SUBJECT: DSUP #2004-0001 – THE PRESCOTT

DEVELOPMENT SPECIAL USE PERMIT  
#2004-0001

Docket Item #13  
DEVELOPMENT SPECIAL USE PERMIT #2004-0001  
THE PRESCOTT (Hopkins Warehouse)

**ISSUE:** Consideration of a request for a development special use permit, with site plan and modifications, for construction of a residential condominium building with underground parking.

**Figure 11 - Fayette Street Elevation**

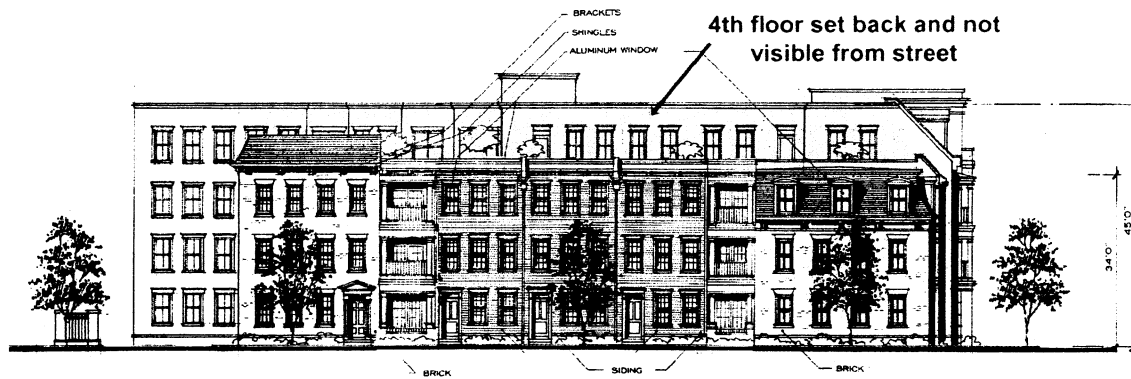
The Fayette Street elevation is the shortest (132.5 feet) facade and is intended to be smaller in scale in response to the buildings on the west side of Fayette Street and to be compatible with the generally smaller scale of the Parker-Gray District. In addition, the entire facade is set back from the sidewalk by approximately 15 feet to mimic the front yards of many houses of the District, such as the townhouses in the 400 block of North West Street. The Fayette Street facade is generally well resolved in mass, scale and architectural character.

Staff recommends the following changes to the Fayette Street elevation:

**Figure 13 - Staff Proposal - Cameron Street**

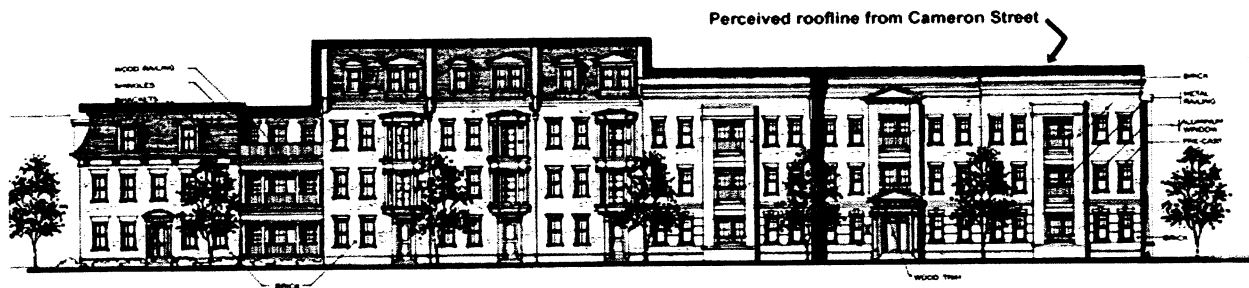
Overall, the proposed facades of an apartment building, three townhouses and a single-family building on the corner provides an appropriate mix of building types for this portion of the City. However, the primarily four-story element on the corner of Cameron and Henry Street is inappropriate to the scale and fabric of the neighborhood. Therefore, staff recommends that a portion of the fourth floor be eliminated, as generally depicted in Figure 13, so that the building will appear as a three-story building from the adjoining streets. This was also a recommendation of the Parker Gray Historic District Commission and a concern expressed by the community. The modification would result in the elimination of up to 4 units and 4,400 square feet of floor area. This elimination of mass at the corner is essential to enable a better transition to the adjoining two- and three-story buildings.

The following changes to the Cameron Street elevations are also recommended:

- The balcony-hyphen shall be revised to be subservient to the single-family building.
- The fourth level balconies for the three central townhomes shall be converted to dormers.
- The two-story balconies for the three central townhomes shall be converted to enclosed balconies consistent with the architectural style of the units.
- The eastern portion of the facade shall be revised per Condition #2.
- The setback for the hyphen shall be at least 8 feet, recessed behind the adjoining building faces, and the balconies shall either be flush with or recessed behind the adjoining building faces.

With these revisions the facade will appear to be two- to three-story, consistent with the character of the historic district. The proposed revisions to the mass also provide more variation in the roof heights, further reducing the perceived mass and scale of the proposed building.

**Figure 14 - Applicant's Proposed Henry Street Elevation**

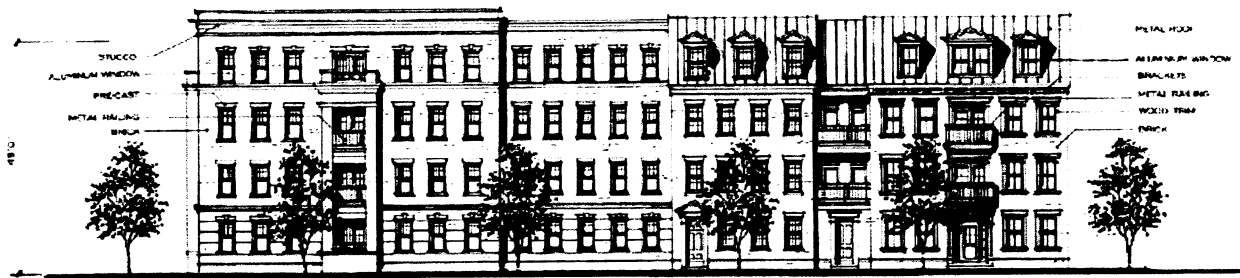
As previously discussed, this facade is the one to which significant revisions need to be made before the mass and scale are compatible with the existing character of Henry Street. As with the Cameron Street facade, staff recommends that the building be designed to appear as a three-story building and that a portion of the building be redesigned with more townhouse bays as generally depicted in Figure 16.

**Fig 15 - Massing Study  
(Proposal in Pink)**

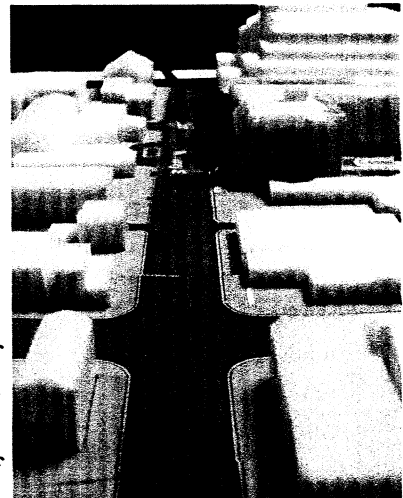
The other concern raised by the Parker Gray Board and shared by staff is the perception of the northern portion of the building on Henry Street. The proposed three- to four-story element is significantly larger than adjoining buildings and will provide an inappropriate transition to the adjoining Bradham auto repair facility. While the Bradham property may redevelop in the future, the northern portion of the building needs to be designed at a scale that is appropriate for the existing condition rather than an assumed future condition. The scale is also significantly greater than the adjoining two- to three-story buildings on Henry Street. For all of these reasons, staff is recommending that the north end of the building be reduced to three stories to provide a better transition. The scale and height of the proposal, even with the staff recommendations, will be considerably more than the one-story gas station and two-story building that are on the site today.

**Figure 17 - Landscaping Plan**

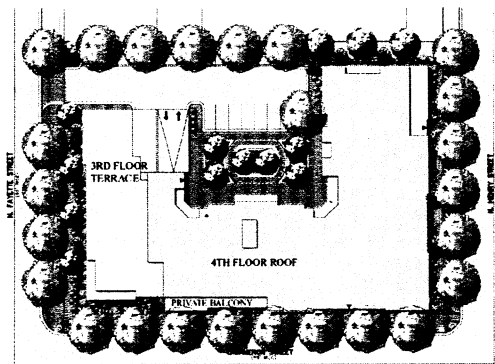
Staff has concerns regarding open space that are related to both quantity and quality. To address the issue of quality, additional landscaping, irrigation and amenities such as benches are recommended to make the ground-level open space more useable and attractive. In addition, staff recommends that the four parallel, at-grade parking spaces be eliminated, that all of the surface parking spaces be compact spaces, and that two additional 90° parking spaces be added. This reconfiguration will result in the net loss of two parking spaces, but will provide additional open space, increase the buffer from the adjoining auto repair facility, and increase the amount of visible open space from Fayette Street.
